How to Match DVE Components

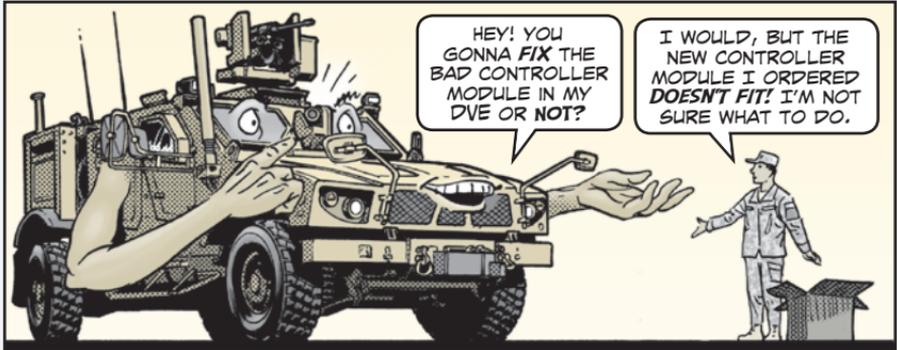
We have an M-ATV with a bad controller module in the driver's vision enhancer (DVE) system.

The new controller module we got from supply doesn't work with the old DVE pan/tilt assembly. But it does work when we use a "good" old-style assembly from another M-ATV.

Are the old control box and electric pan/tilt assembly made by DRS before 2011 supposed to be interchangeable with the newer control box and pan/tilt assembly made by BAE Systems? If they have to be replaced as a set, it seems like a pretty costly repair.

Unfortunately, the old and new style components are not interchangeable.

So if you have the older pan/tilt assembly, NSN 5855-01-590-4576, you'll need an old-style controller module, NSN 6110-01-590-4871. And the new-style pan/tilt assembly, NSN 5855-01-591-0050, requires the new controller module, NSN 6110-01-591-0045.

To keep it simple, just remember that old goes with old, and new goes with new.
